Review of the Tunnel Crossing of the New River in Fort Lauderdale, FL

Document no: Technical Memorandum
Version: FINAL Rev 2.1

Client Name: Broward County

Jacobs Project No.: D3864500
June 7, 2024

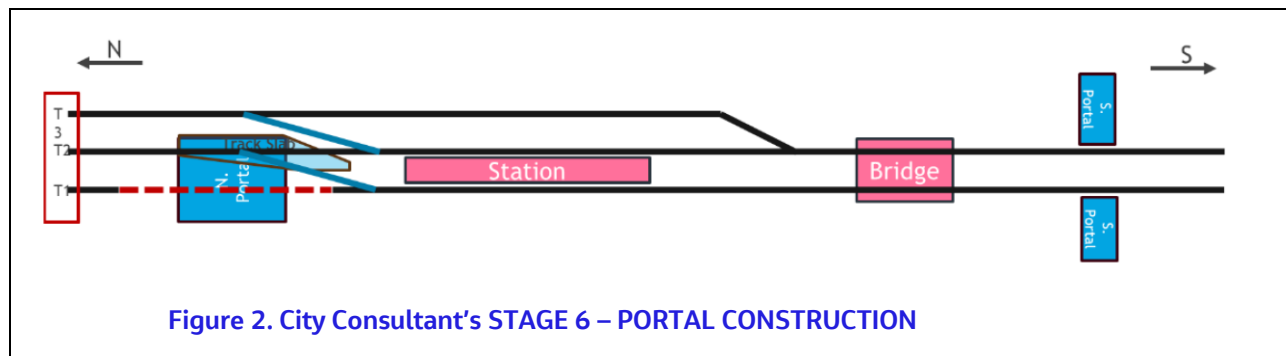
The transition between the cut-and-cover and TBM tunnel sections needs to be clarified. The required bellmouth structure may interfere with the existing railway construction sequence. Refer to [Figure 1](#) for Transition From Tunnel Approach to Cut-and-Cover on North and South Ends.

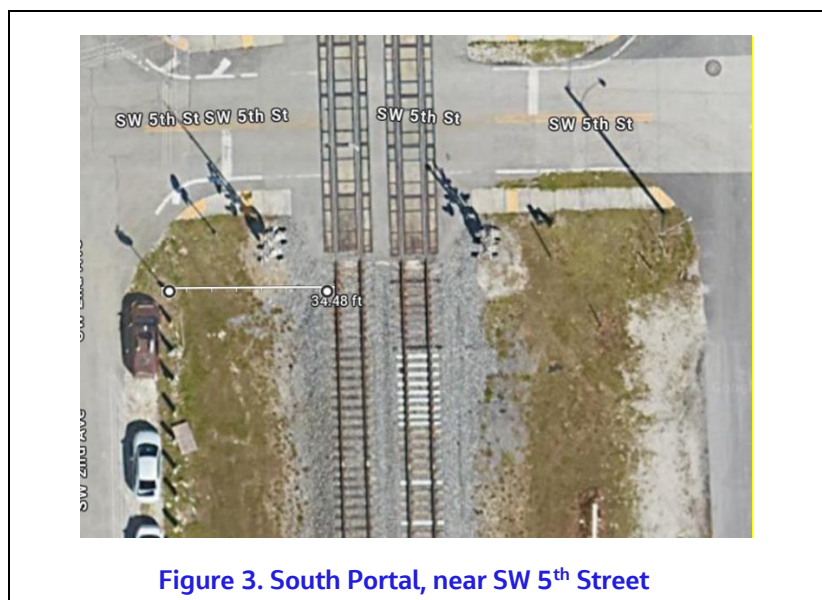
The proposed excavated outside tunnel diameter is 28 feet. To receive the TBM, the receiving pit is approximately 44 feet wide, which includes 28 feet tunnel outside diameter, 5 feet either side clearance of the tunnel (i.e., 10 feet total), and the 3 feet width of the SOE on either side of the pit (6 feet total).

The railroad easement is about 100 feet wide. To construct two TBM receiving pits, each at least 44 feet wide, during live tracks is not feasible, as shown in [Figure 3](#).

The distance between the west easement limit to the edge of the southbound track is about 35 feet, which is smaller than the required width of a 44-foot-wide TBM receiving pit. This will require single tracking operations for FEC and Brightline during the construction of the west side South portal.

Figure 5. Proposed North Portal location between NW 4th and NW 5th Streets

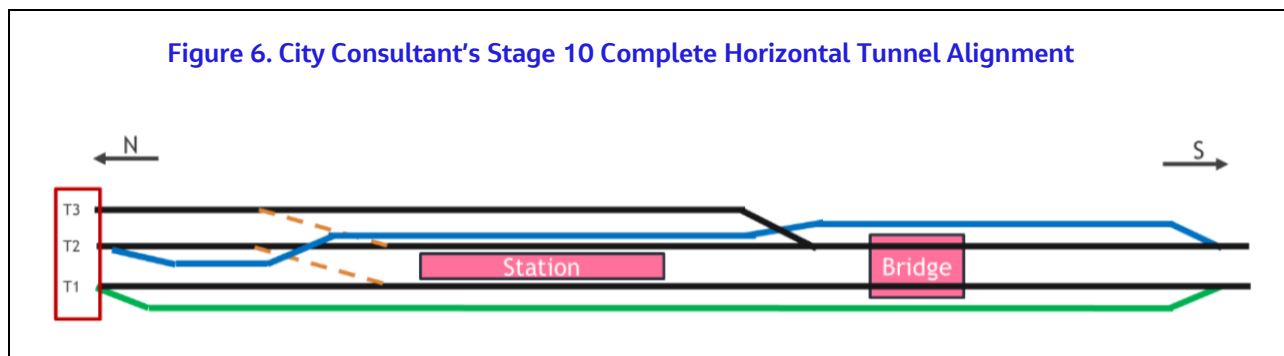
One combined TBM launching and receiving pit was proposed at the North portal, as previously shown on **Figure 2**. The construction of this TBM launching and receiving pit is unfeasible for the following reasons:

- Constructing the receiving pit west of Track 1 will require significant encroachment on adjacent property, since minimum space exists between Track 1 and the ROW.
- Minimum combined TBM launching and receiving pit is about 82 feet, which includes the two TBM outside diameter (28 feet each), pillar between two tunnels (10 feet, which needs extensive ground improvement to keep tunnel stability during construction), 3 feet SOE wall on each side (6 feet total), and 5 feet clearance each side of the SOE.
- The TBM launching and receiving pit will encroach not just Track 2, but also Track 3.

Refer to **Figure 5** for North Portal clearances.

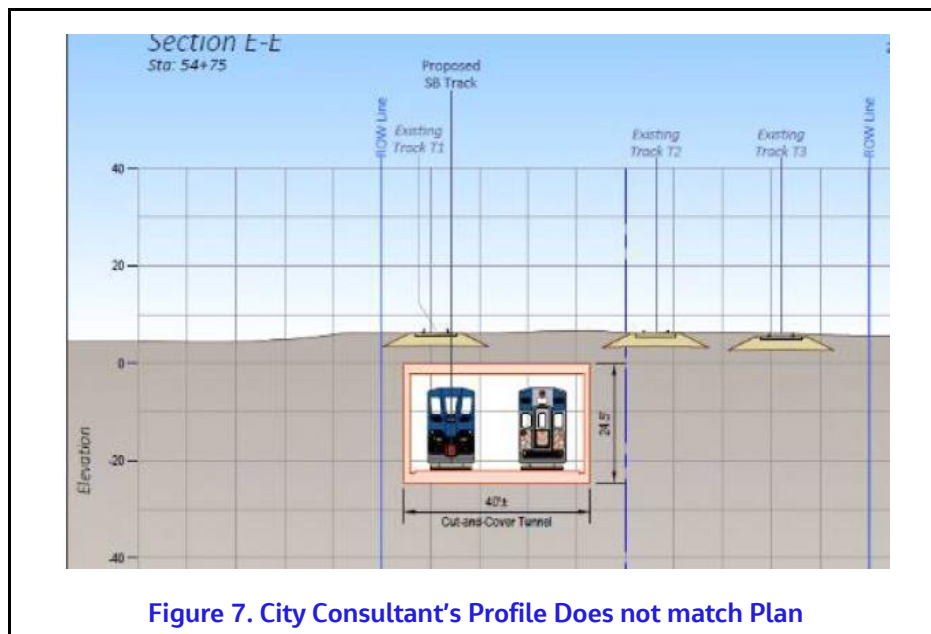
The transition from the underground track to the surface track on the North end of the alignment has some unrealistic horizontal curves. As shown in Figure 6 without a geometric layout, the total tunnel length of the proposed scheme cannot be verified because of the several horizontal and vertical curves. The actual tunnel length could be longer than that proposed in order to accommodate the minimum geometry for the curves. In addition, the two "S" curves shown on the north bound underground track will be difficult for TBM excavation. These "S" curves also need to follow railroad operational and safety requirements.

The plan for the northern segment of the tunnel depicted, shown to be SEM and Cut & Cover, does not match the profile. The plan shows it on the West side of the ROW, yet the Cross Section shows it on the East side of the ROW. Refer to section 3.4.2 for discussion related to railroad vertical and horizontal curves.

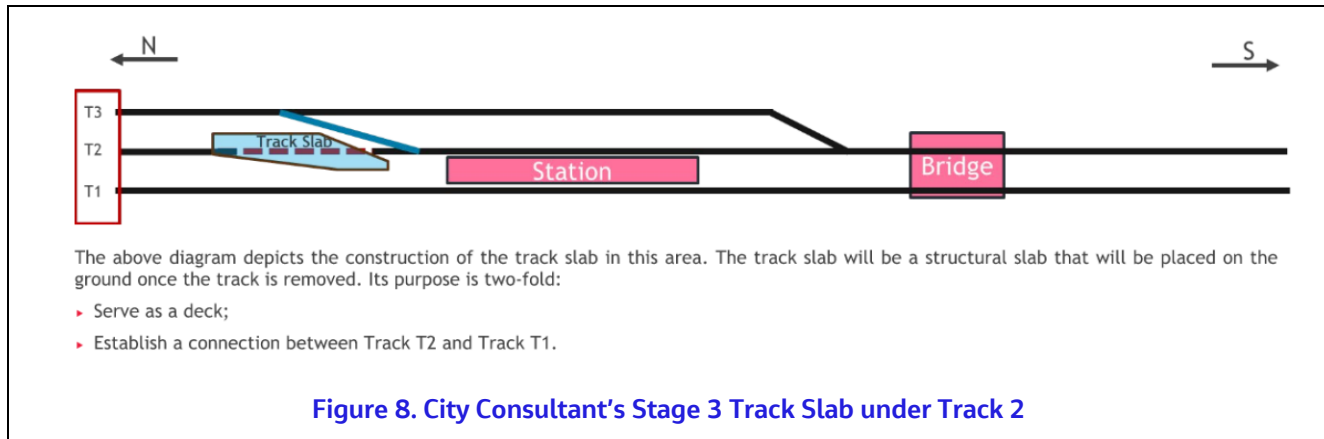
As mentioned earlier, the TBM launching and receiving pit dimension will encroach on Track 2 and Track 3 due to the total dimension and clearance required. The proposed surface track slab as part of the future cut-and-cover tunnel roof structure is not desirable. As shown on Figure 8 below, the proposed Stage 3

from the City Consultant's construction sequencing solution will be difficult to achieve, or unfeasible from structural and waterproofing perspectives. In addition, all the edges of the "slab" are cold joints, where waterproofing detail requires special attention for its long-term performance.

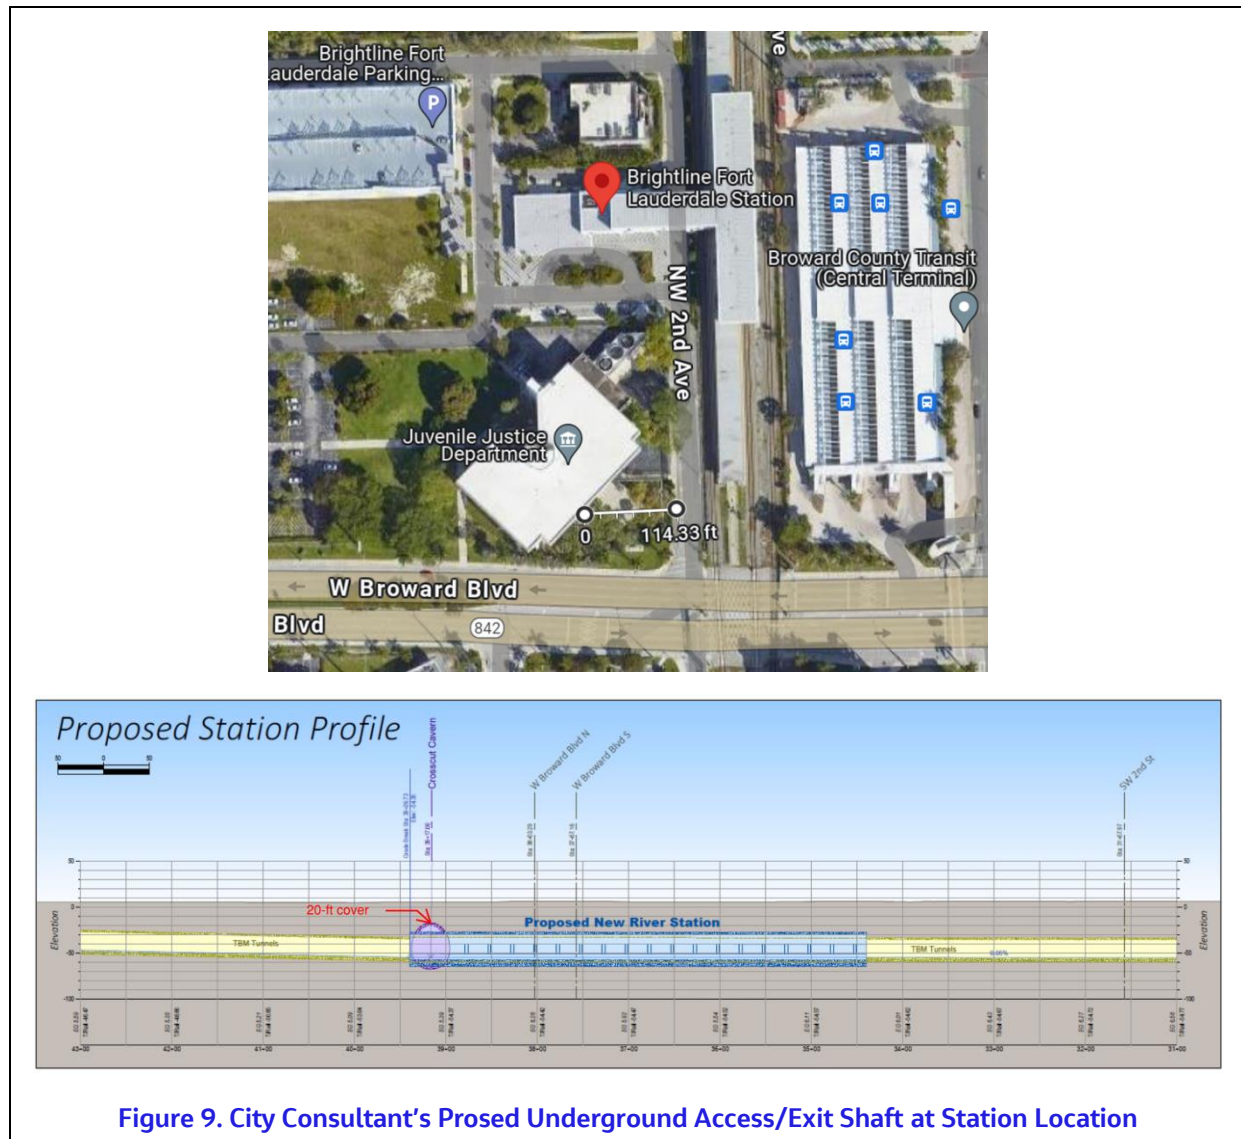
The proposed underground station to serve the commuter rail passengers is located south of the existing Brightline station, underneath Broward Blvd. The proposed station's access shaft will be located from the vacant lot of the existing Juvenile Justice Department's building, as shown in [Figure 9](#).

The size of the lot for an access/exit shaft is small from a construction perspective. The shaft has to house all underground systems operation and ventilation equipment in addition to passenger circulation. In addition, the station requires at least two underground egresses to the surface; only one is provided. An additional means of egress will be required for emergency exit and access purposes.

Figure 10. City Consultant's Proposed Underground Station Plan and Profile

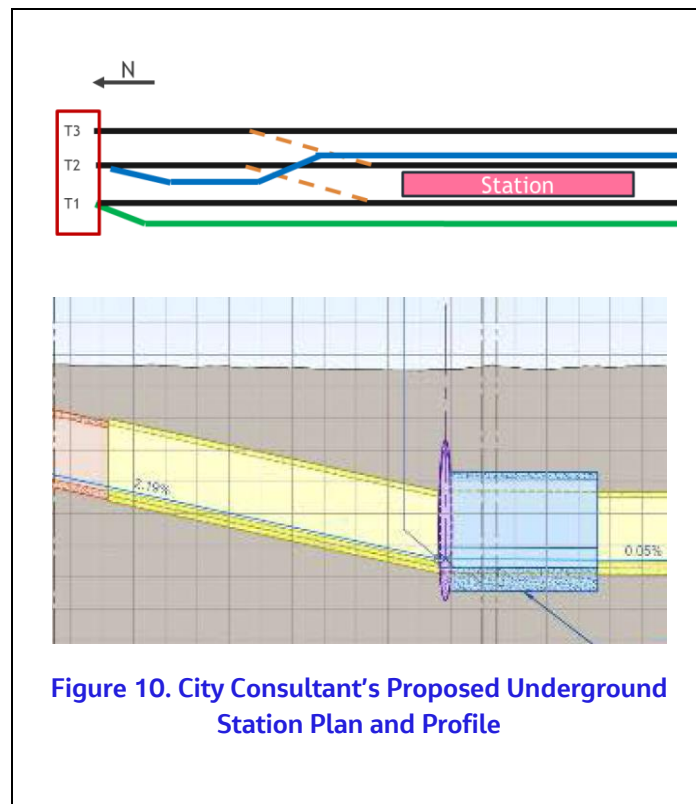
The proposed alignment requires a short distance of a 4% grade over 600 feet on the south side of the tunnel, exceeding Brightline's preferred maximum grade of 3%. The City Consultant states that it is acceptable for passenger trains to exceed the 3% grade for a short distance. This steep grade this close to a station is not desirable from a train operations perspective. While a short 4% grade located in a running section can benefit from the momentum head generated by a moving train, a train departing the station will be at lower speeds and could have issues surmounting the grade.

As shown in [Figure 10](#) the transition to and from north of the station with a vertical slope of 2.19% combined with a horizontal curve is unfeasible, and to accommodate it may require a longer tunnel. Section 3.7.1 of the AREMA Manual provides details related to Compensated Gradients, where a curve on a slope needs to be compensated 0.04% per degree of curve, to account for the added resistance of a train on a curve. Therefore, reducing the slope could be used on a tangent section of track.

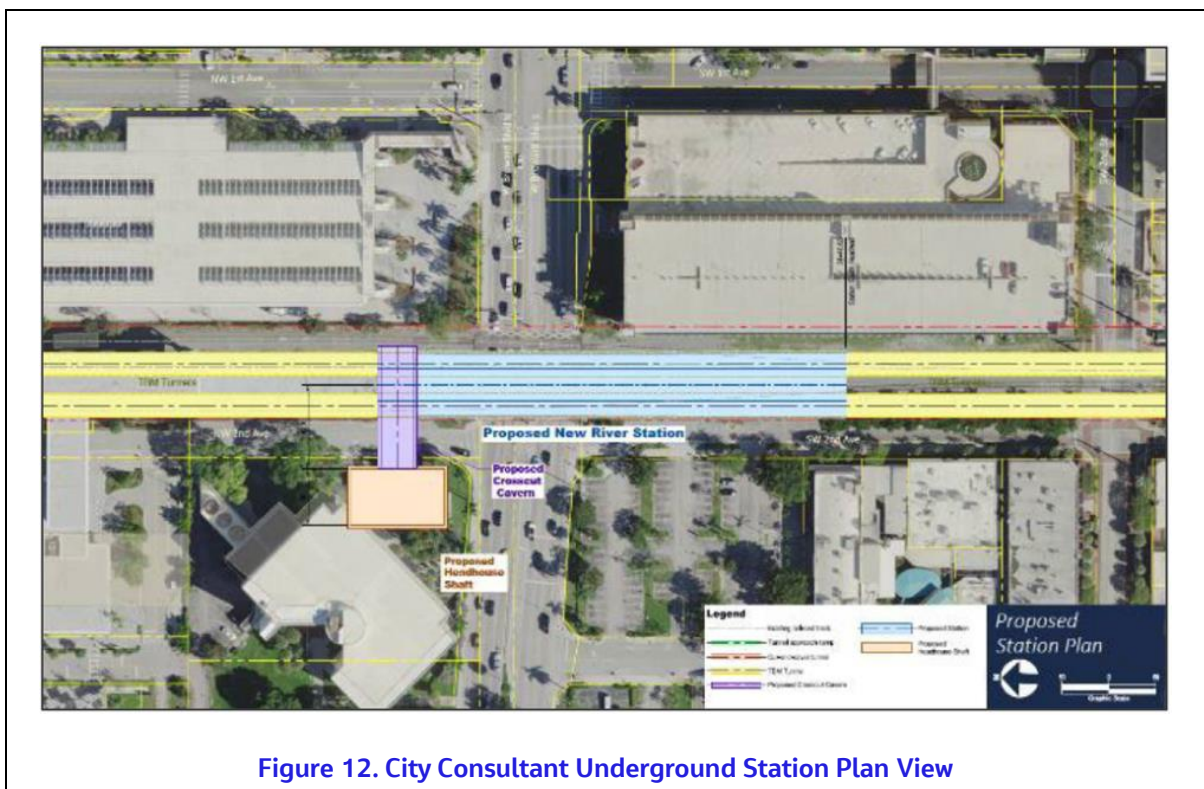
A FLS preliminary assessment should be provided to identify the minimum number and the position of cross passages, ventilation, and emergency access shafts and position of (if any).

The tunnel will be excavated through loose soil with low overburden and potentially high ground water levels. The construction of cross passages may require extensive ground improvement measures that can increase cost, and could potentially induce significant settlement. For example, the POMT required freezing the ground and water to -22 degrees Fahrenheit to stabilize the ground enough to safely construct cross passages.

Figure 13. Geological profile under New River (Quest)

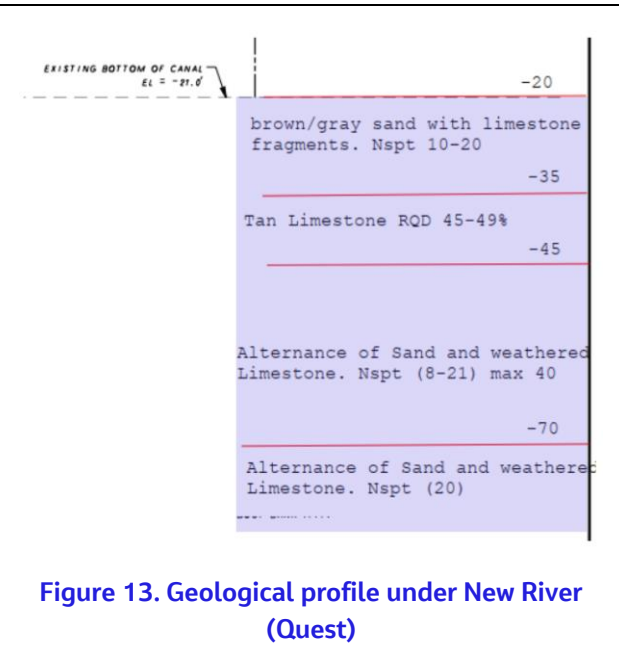
Borehole B6 is the most likely representative of the ground conditions at the New River underpass. The results of the boring indicate that the ground is mostly soil, with a small layer (about 10 feet) of weak limestone rock at the tunnel crown. The limestone rock has an RQD (Rock Quality Designation) of 45-49%, which indicates that it is weak and fractured. The weak rock could potentially influence the tunnel excavation. The geological profile under New River is shown in [Figure 13](#).

It is concluded that the City Consultant's tunnel option will encounter mix-face tunneling condition (some portions in soft ground and some portions in rock). For example, since the proposed tunnel is very shallow, its crown will be exposed to sandy material.

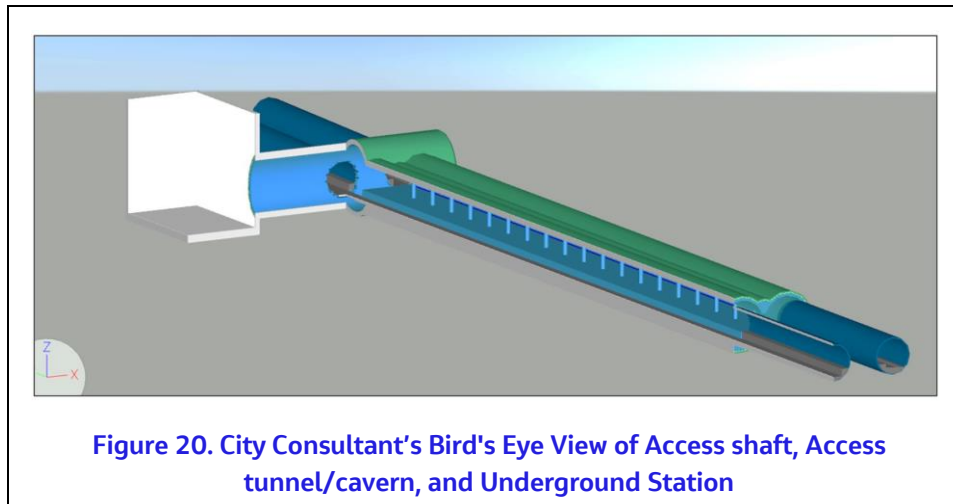
Figure 20 provides a bird's view of the underground station. Construction of the underground station and its access tunnel (leading to the shaft) will be in sand with NSPT (Standard Penetration Test blow-count

number) from 0 to 10 (Quest Borehole B7 – sand layer from ground surface to Elevation -60), which indicates very loose to loose and low strength material (note – NSPT number and its relative Density relationship: 0-4, Very Loose; 4-10, Loose; 10-30, Medium; 30-50, Dense; over 50, Very Dense).

Underground construction in this type of very loose to loose ground with high groundwater table has significant risk of losing ground stability during excavation. A significant amount of ground improvement (such as ground freezing) will be required.

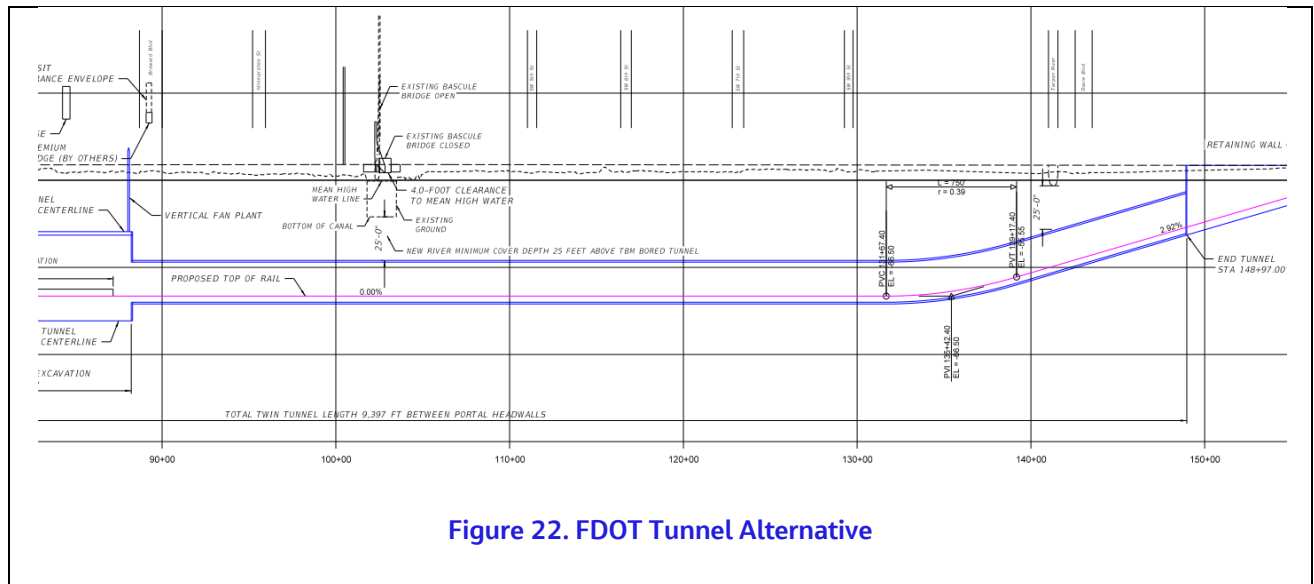
The tunnel is proposed to be excavated with less than 15 feet of cover (see [Figure 21](#)). A detailed bathymetric and geotechnical assessment should be conducted to confirm the viability of the tunnel under passing the New River with such limited overburden. A detailed tunnel buoyancy calculation should be performed to ensure the tunnel's stability under the river.

The City Consultant's proposed alignment will have a different approach than the previous solution developed by FDOT (see [Figure 22](#)). It will rise immediately after crossing the river, which will result in a shorter tunnel length. However, this approach may cause settlement impacts in different areas than what was initially anticipated and assessed in the FDOT tunnel alternative. If a decision is made to further pursue an adjusted tunnel alternative, a detailed easement study and settlement analysis needs to be conducted.
